Product Change Notice (PCN)

PCN Number: PCN-0485189R-01

Product(s) Affected: *CPM1207 Series (CPM1207-02A-02-FRA-M9-67, CPM1207-03A-02-FRA-M9-67, CPM1207-04A-02-FRA-M9-67, CPM1207-05A-02-FRA-M9-67, CPM1207-05B-02-FRA-M9-67, CPM1207-08A-02-FRA-M9-67, CPM1207-12A-02-FRA-M9-67, CPM1207-17A-02-FRA-M9-67)*

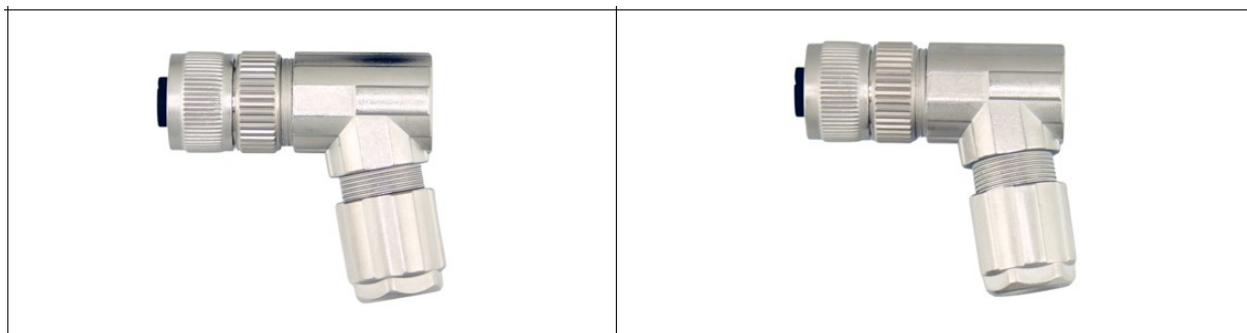
Description of Change:

Material differences

- Female terminals have changed from brass to phosphor bronze

Mechanical differences

- Previous operating temperature -25, new operating temperature -40

Visual differences shown below
